**RE: MAJOR PROJECT 08_0014 – 63 LOT RESIDENTIAL SUBDIVISION, MORISSET PARK –
REQUEST TO AMEND CONDITION B9 ROAD DESIGN**

1. INTRODUCTION AND PROPOSED AMENDMENT

Austroads Part 4A 2010 Figure 4.9 Warrants for turn treatments on the major road at unsignalised intersections

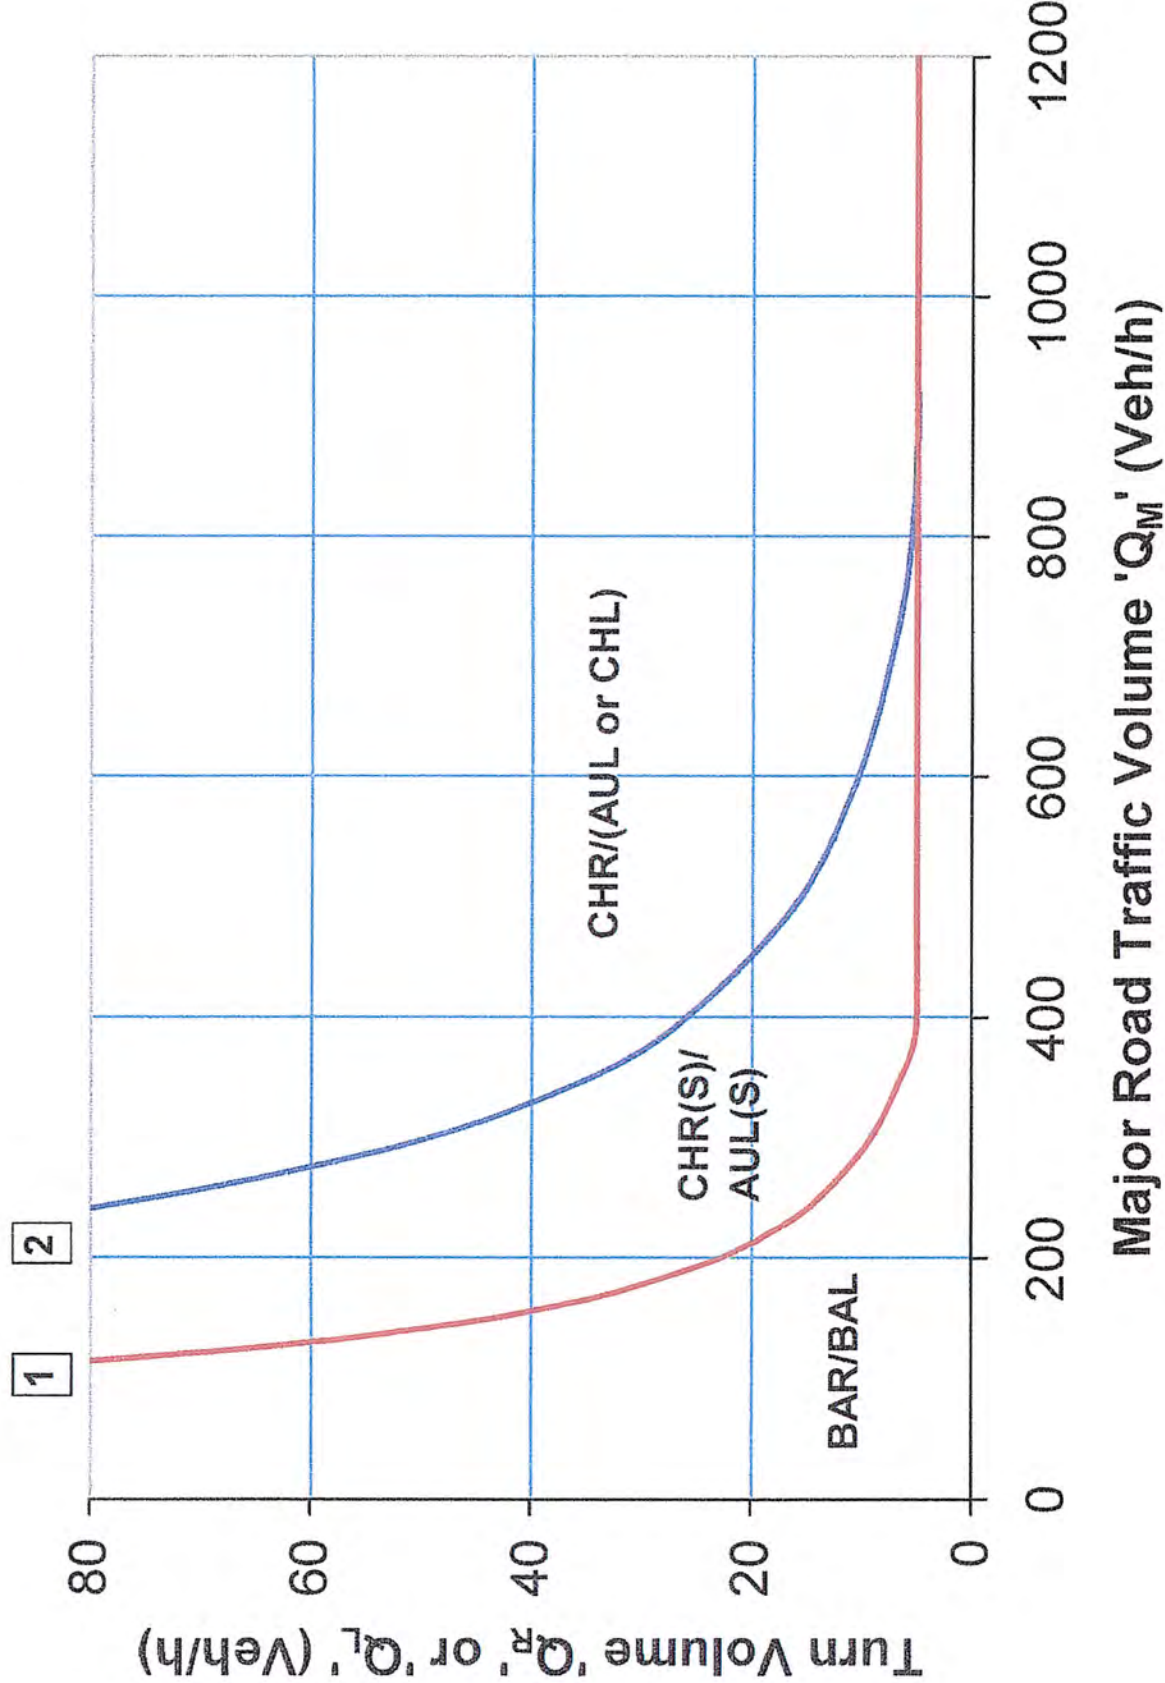
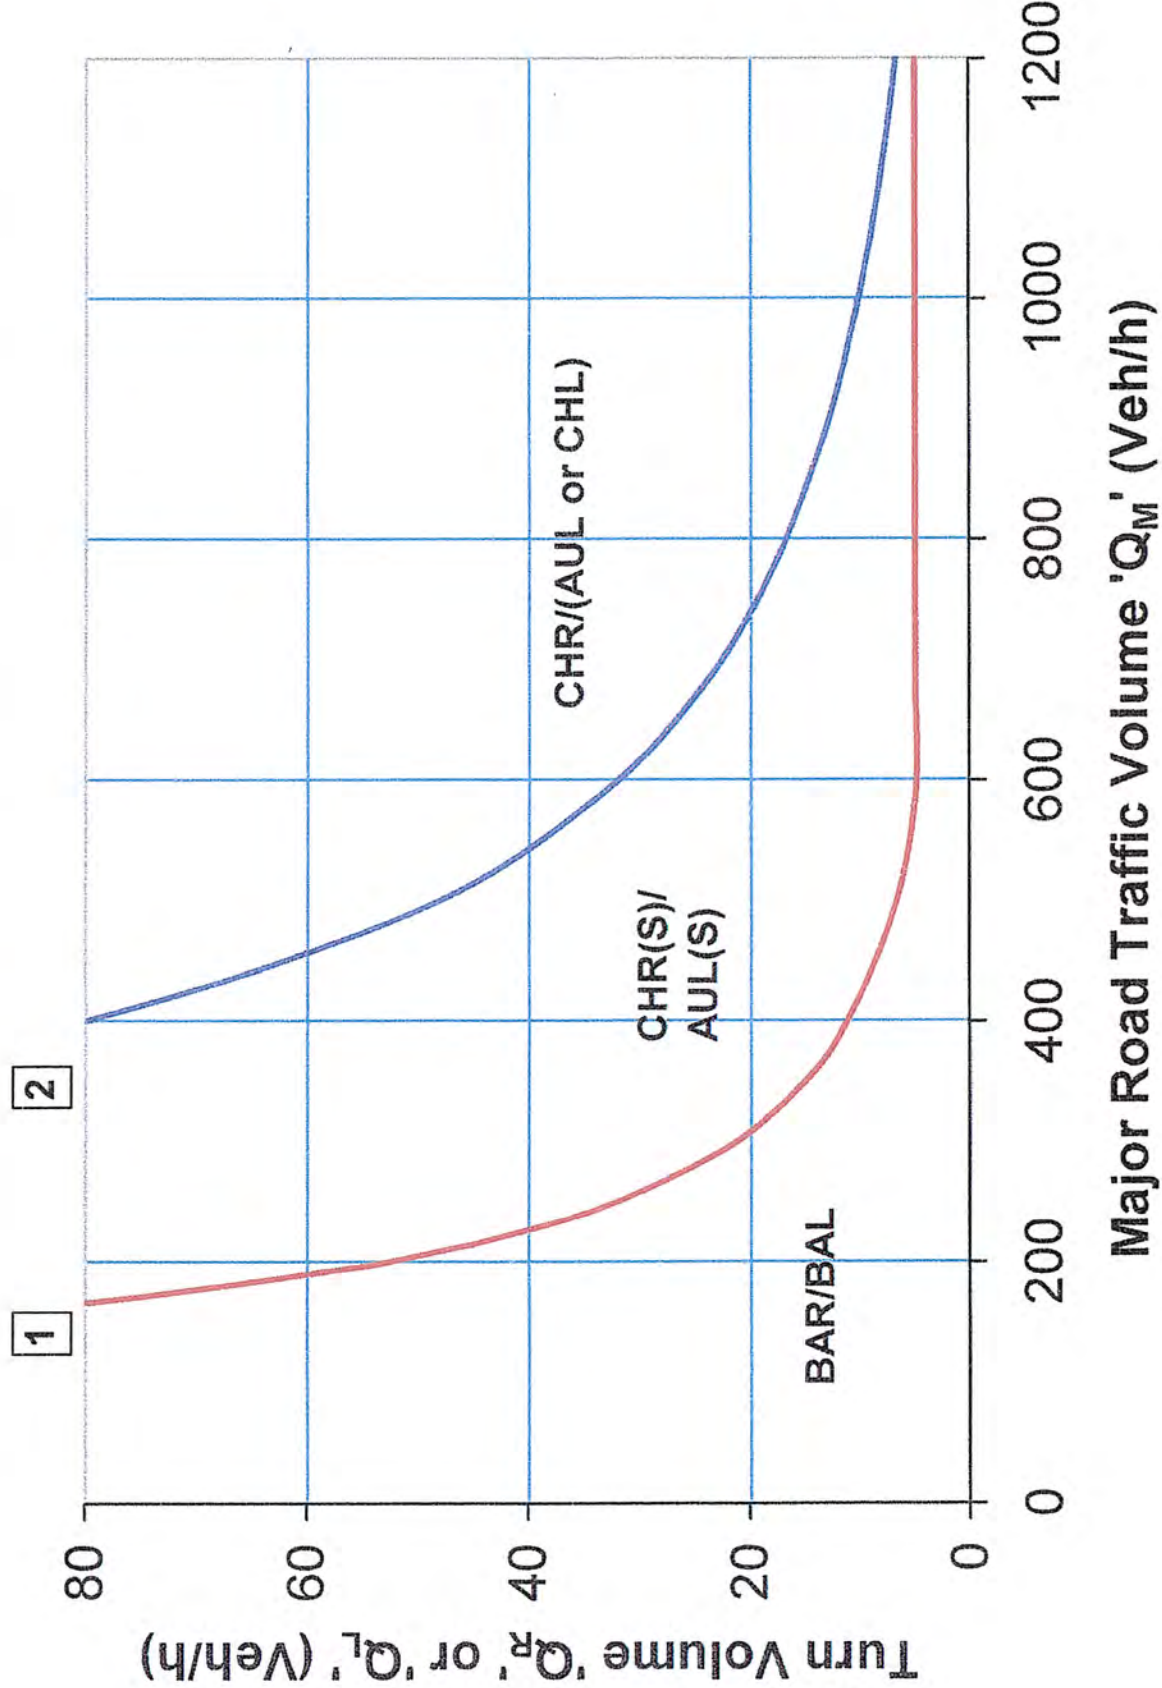
Austroads Part 4A 2010, page 46 Figure 4.9 (extract attached at **Attachment 4**) shows guideline warrant graphs which are used to determine the appropriate type of intersection.

If the existing volumes shown in the 2009 TPK report and the expected impact of this development are taken into consideration, the implied intersection improvements for Morisset Park Road and the new access road remains at BAR based on the 2010 Austroads reference (i.e today's standards).

We acknowledge pursuant to Figure 4.9 the implied intersection improvements required for the Chifley Road intersection is CHRS. Notwithstanding this, TPK in their traffic analysis attributed the impact of the subject development on the Chifley intersection to be valued at 20% of the total intersection upgrade. Increase in right turns into Chifley Road as a result of the development will be minimal. Furthermore, TPK in their traffic analysis stated, *'of the total developments identified in reports referenced by TPK for this review the subject development represents around 1% of the total increase in traffic demand on the road network.'*

The CHR level is for larger right turn volume situations where the potential for almost constant “standing to turn right” on the through road warrants an exclusive right turn bay. Currently there is around 4 vehicles per hour (peaks) turning right into Chifley from Morisset Park Road – clearly BAR on Figure 4.9 Part 4A (**refer to attachment 4**).

The subject development is minor in comparison to the overall peninsular developments considered in the project analysis (2009) and will increase Chifley right turn in by no more than 1vph and the New Access intersection will generate no more than 1vph right turn in – again BAR is indicated on Figure 4.9 Part 4A.

- b. A BAR intersection shall be constructed for Morisset Park Road and Chifley Road;*

- c. A BAR intersection shall be constructed for Morisset Park Road and the New Access Road to the subdivision, including the provision of bus amenity;
